Tolerances for initial condition coefficients

(comment #333)

IEEE P802.3dj Task Force

September 2024 (r0)

Coefficient initial conditions

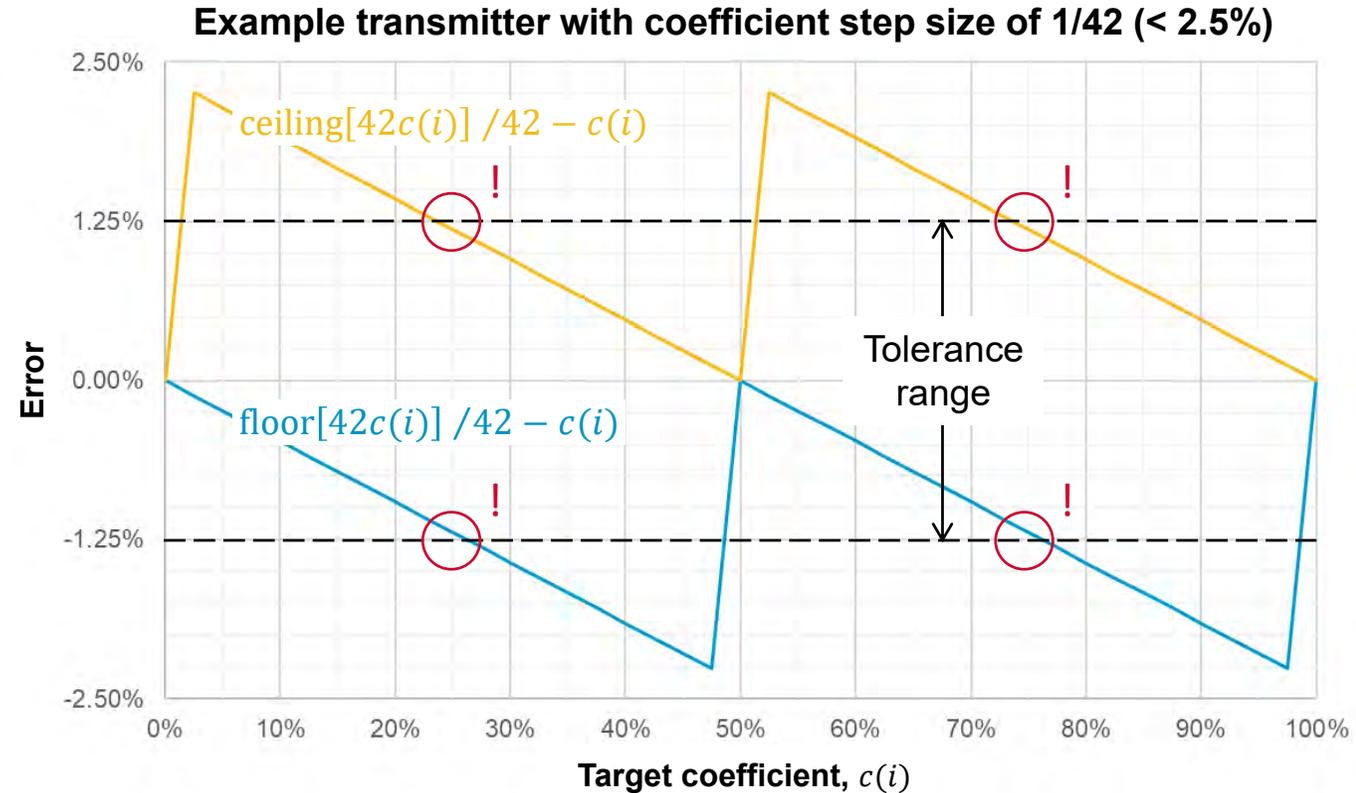
- The coefficient tolerance range for transmitter equalizer initial conditions is $\pm 1.25\%$
- It is possible to get very close to these limits even with a compliant coefficient step size
- This is the result of misalignment between the set of achievable coefficient values the 2.5% “grid” on which the nominal initial condition coefficients are based

Does the tolerance range need to be that tight?

- Issue is more pronounced for coefficient step sizes closer to the 2.5% limit
- Example shown reflects the native step size for a 7-bit digital-to-analog converter
- There is very little margin to the specification for this otherwise valid implementation

- Very precise initial condition coefficients are not necessary since ...
- ... a receiver feed-forward equalizer is likely available to make local adjustments or ...
- ... additional transmitter adjustments can be made using increment and decrement commands

- Recommend increasing the coefficient tolerance range to $\pm 2.5\%$
- This modest increased in tolerance range still provides a very reliable starting point for link training
